NASA Engineering and Safety Center Technical Consultation Report	Document #: RP-06-115	Version: 1.0
Title: ISS S-Band Corona Discharge Anomaly Consultation			Page #: 1 of 26

International Space Station (ISS) S-Band Corona Discharge Anomaly

December 14, 2006

Figure 7.2-1. Breakdown Voltage versus Pressure for Various Gaps (in air) from Woo Curves (ref. 6)

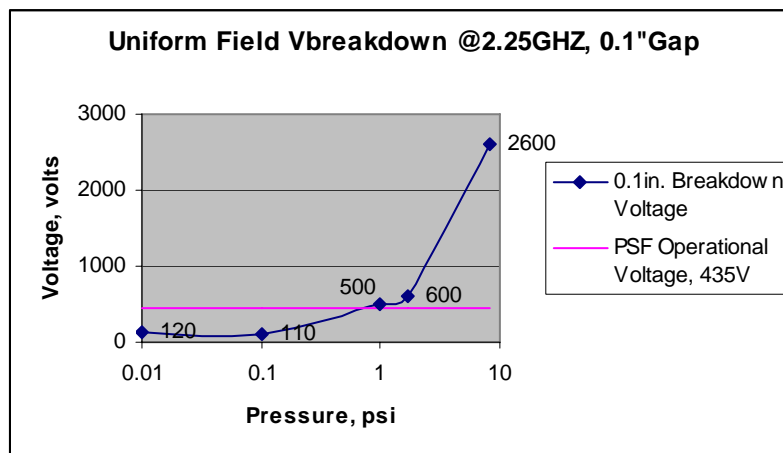
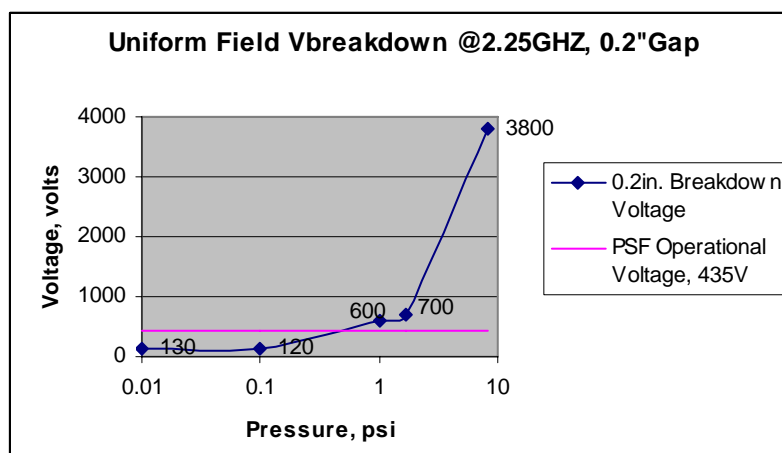
The charts in Figure 7.2-1 show the RF breakdown voltages for a range of pressures in an air environment (refs. 5 and 6). For the purposes of this analysis, N₂ and air are considered

equivalent. As discussed, the actual levels need to be determined by test, as the data is retrieved from the ideal case of uniform fields.

However, it can be seen that the worst case range is between 0.01 and 1 psia and the inception level is so low that corona is likely.

1. At pressures between 0.001 psia and 1 psia, corona is almost certain (>90 percent) for the gap sizes within these assemblies (>90 percent).
2. At pressures of greater than 2 psia, corona at any gap size is unlikely (<10 percent).
3. Between 0.1 and 1 psia, the margin between the operating voltage and corona inception level is essentially non-existent, and the likelihood of corona should be moderate (~70 percent).
4. Below approximately 0.001 psia, multipactor breakdown dominates over ionization breakdown. Corona does not occur in hard vacuum (e.g. <0.00001 psia). However, multipactor breakdown is still possible for small gaps (0.1 inch) in this pressure region, so a breakdown probability of 50 percent would be appropriate.

In the 1 to 2 psia region, the probability of corona is undefined. This is the “knee” of the Paschen curve where the breakdown voltage characteristic changes greatly with small changes in pressure.
